## Product Change Notification

**1. ECR #:** 25-24901-1  
**Notification #:** 775

**3. Series:**  
• UMPT - UMPT ASSEMBLY

**4. Part #'s Affected**  
• UMPT-XX-01.5-XX-V-X-X-X-X-XR

UMPT body, Bottom Side-Before Change.

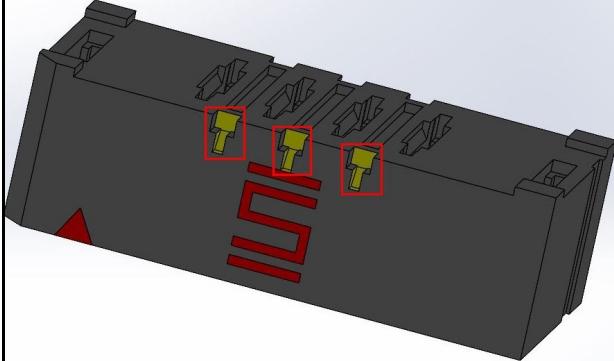
**5. Description of Change:**  
Voids changed for both top and bottom side.
